## **Apple II Reference Manual**

The main logic board of your Apple has been modified to reduce electromagnetic interference. This means that it is different from the Apple boards which are described in the Apple II Reference Manual. It will not, however, behave differently in any specific way unless you have changes made to it.

You will know you have a new main board by looking at the white F on the far left side of the board. You'll see there this nine digit number 820-0044-xx, where xx is the revision level.

Replaces Figure 22-1. Schematic Diagram of the Apple II

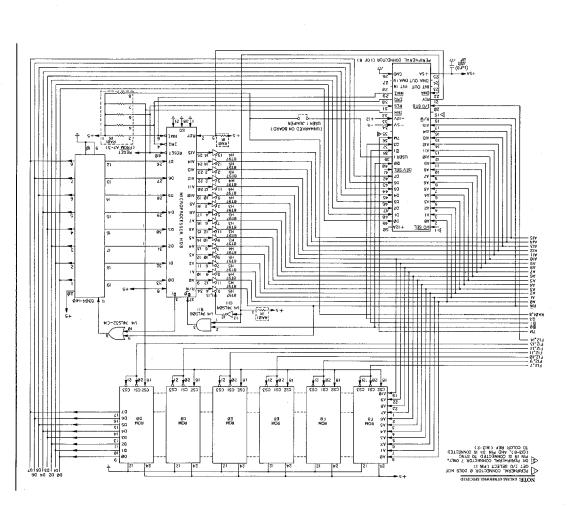
The major differences in the new main board are described below. Also, the attached schematics show the areas in which this board is different from earlier boards. You may wish to note these differences in your Apple II Reference manual, on the pages which correspond to the schematics here.

- \* The new board does not have RAM configuration blocks. This means the RAM Integrated Circuits (ICs) which give your Apple its memory MUST be 16K bit ICs. All of the RAM ICs in your Apple are within the white-outlined box on the board. If you add memory to your Apple, make sure all the ICs you add in this box are 16K Apple RAM.

- \* The IC which controlled the configuration blocks in the older versions of the Apple II board is no longer there. It was formerly in the E2 position on the Apple board (in the row labeled E, the second IC from the left of the board) and was marked 74LS139.

- \* This new board has a different character generator ROM IC. The character generator ROM IC determines what style of lettering, or character set, you'll see on your monitor or terminal screen. The new character generator ROM is found next to the Keyboard socket on the main board. This 2316B ROM has more space than the former 2513 character generator ROM, so that it's possible to have more than one character set available. The 2316B ROM can also be replaced with a 2716 EPROM, which allows you to program and change your own character sets.

- \* The color killer circuit, which damps out the color burst when your Apple is in text mode, has an added cutout circuit. The color burst is cut off in the logic circuit before it gets to the tank circuit. This gives you good black and white text, even if your color monitor has a sensitive color burst detector.
- \* The power and ground system has been redesigned. The +5V and ground bus on the rear of the board have been interchanged so that
- the +5V bus is on the top of the board and the ground is on the bottom. A grounding bar has been added under the board to ensure
- electrical contact between the board and the metal baseplate. Additional filters have been added to further reduce the EMI
